OPERATIONS BULLETIN #24-06

Date: 11/25/24
Apparatus: Tactical Tender – 2024 Freightliner M2112
Subject: Rear Suspension

SS 3073-FTL2021 M2 Rear Suspension Knock

Outboard side / aft end of left rear spring

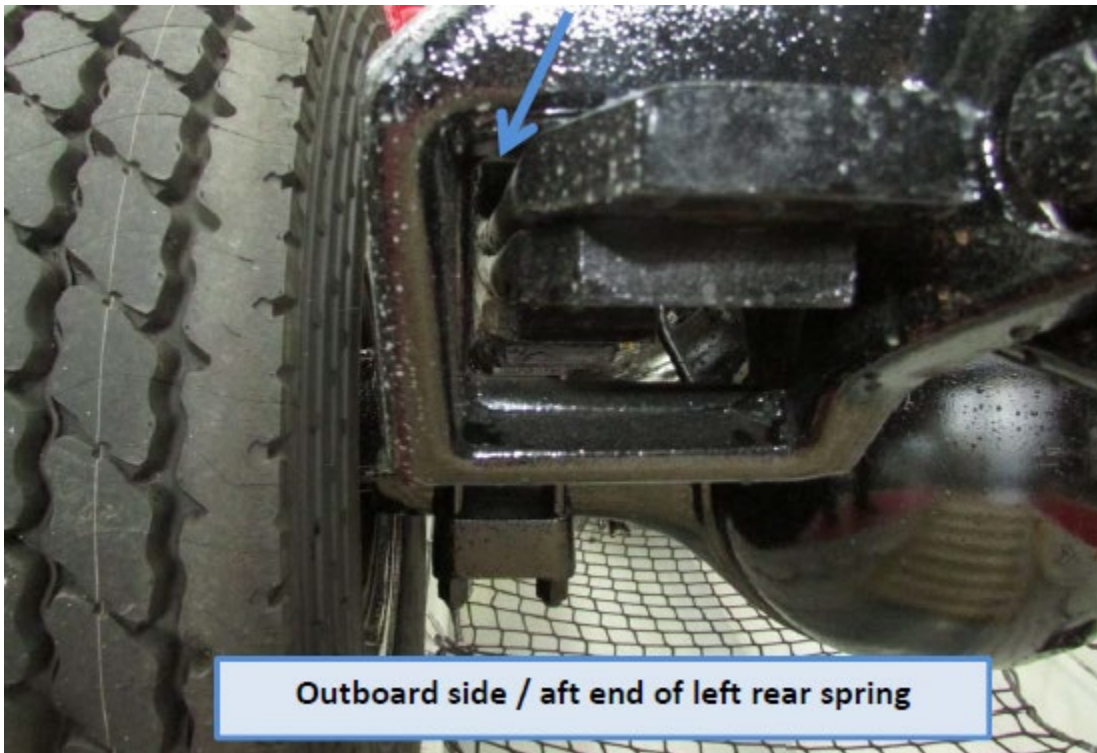
The FTL flat leaf spring rear suspension permits the spring pack to shift laterally within the spring hanger brackets. Under heavy cornering load applications, the spring pack can shift laterally and contact the sidewall of the spring hanger bracket. (See Image 1 for reference)

Fig. 1

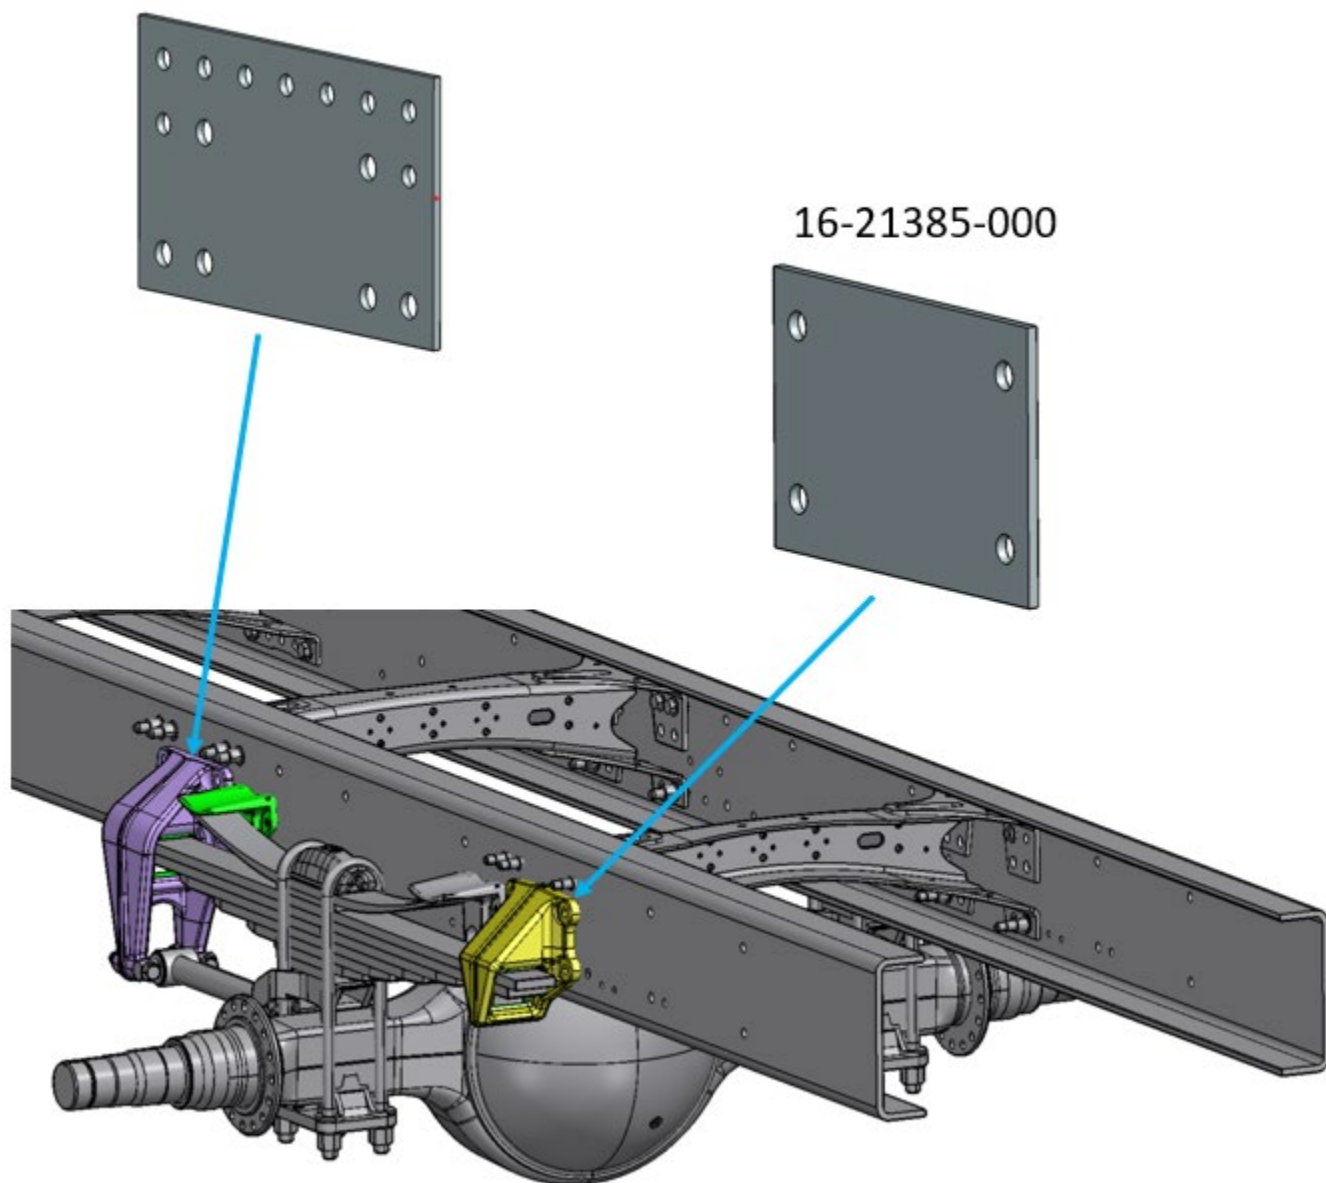
- c) c. 16-21385-000, QTY 2 for all suspensions
- 4) Install 15-15519-000 spacer plates between the forward spring hanger brackets and the LHand RH frame rails (see Fig 1 and Fig 3).

- 5) If the suspension includes a helper spring bracket, the 15-15519-000 spacer plate will need to be modified to provide clearance (see Fig 2)
- 6) Install the 16-21385-000 spacer plates between the rear spring hanger brackets and the LHand RH frame rails (See Fig 1 and Fig 3).

Fig. 2

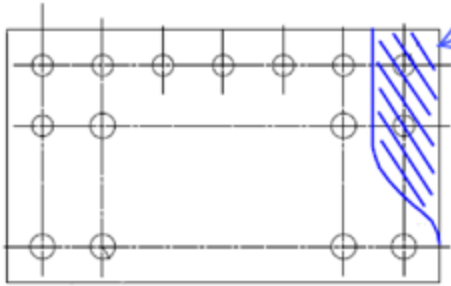
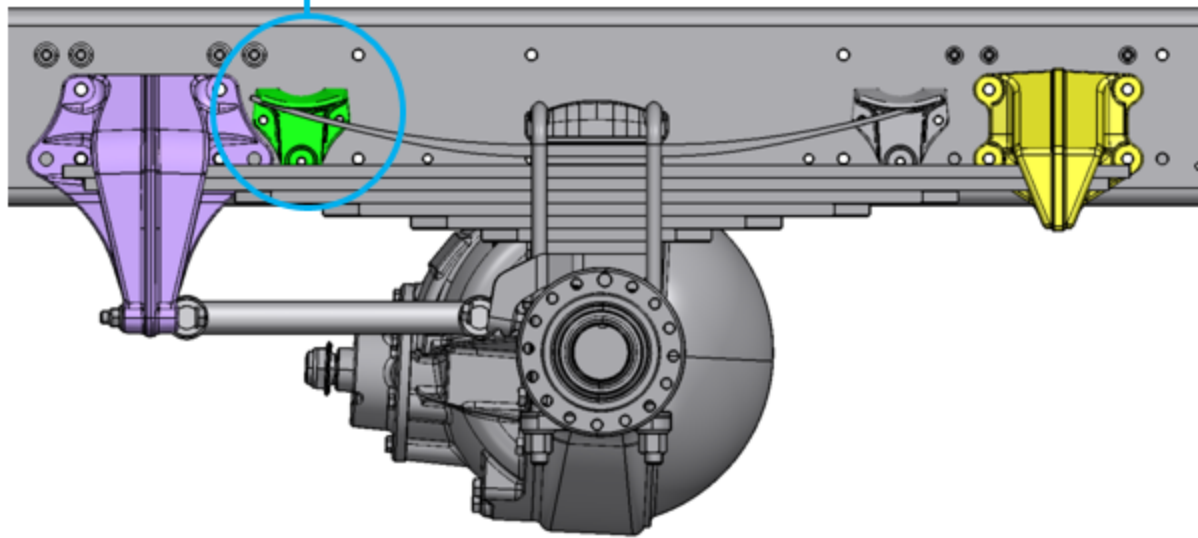
Cross hatch area must be removed as shown for clearance with helper spring bracket.

This is only required when helper springs are present.

Fig. 4

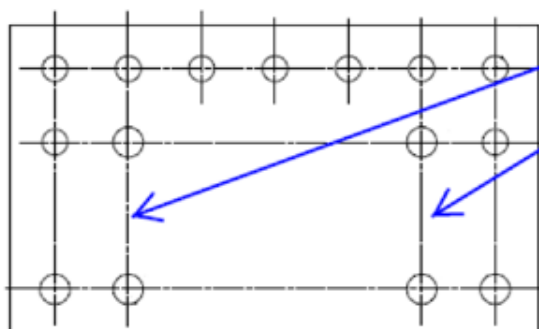
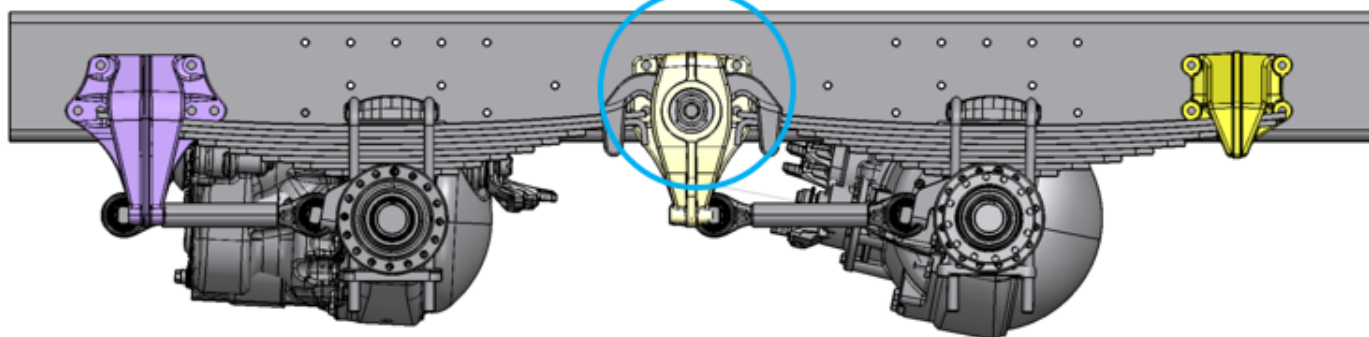
- 7) For tandem axle suspensions, install the 15-15519-000 spacer plates between the equalizer brackets and the LH and RH frame rails. The 15-15519-000 spacer will need 2 additional 20.6mm diameter holes drilled for correct fit-up (see Fig 4)

Use equalizer as drill template for
additional hole - (2) places as shown

Required for fitment behind
equalizer bracket.
